Project	IEEE 802.16 Broadband Wireless Access Working Group < http://ieee802.org/16 >
Title	Enhancement for rate 2, 4-transmit antenna STC
Date Submitted	2005-1-10
Source(s)	Jianzhong (Charlie) Zhang, Kiran Kuchi, Anthony Reid Voice: 972-374-0958, 972-374-1862 Fax: 972-894-5937 charlie.zhang@nokia.com , kiran.kuchi@nokia.com Nokia 6000 Connection Drive Irving, TX 75039
Re:	IEEE 802.16e D5 Draft
Abstract	Proposes an enhancement to rate 2, 4-transmit antenna space time code
Purpose	To incorporate the changes proposed here into the 802.16e D5 Draft.
Notice	This document has been prepared to assist IEEE 802.16. It is offered as a basis for discussion and is not binding on the contributing individual(s) or organization(s). The material in this document is subject to change in form and content after further study. The contributor(s) reserve(s) the right to add, amend or withdraw material contained herein.

Enhancement for rate 2, 4 transmit antenna STC

Figure1: FER performance of circulated matrix B

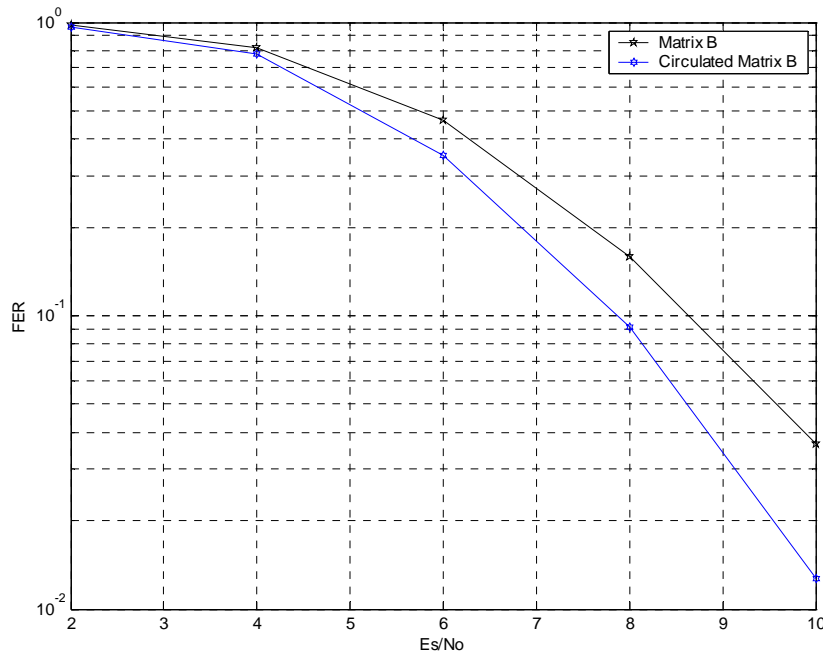
In Figure 1, we compared the FER performance of the circulated code to Matrix A for 4 Tx and 2 Rx case in for Ped A channel, rate 1/2 convolutional code, QPSK modulation using LMMSE receiver. We notice an increase in coding gain up to 1.0 dB. Similar gains are expected for other modulation and coding modes.
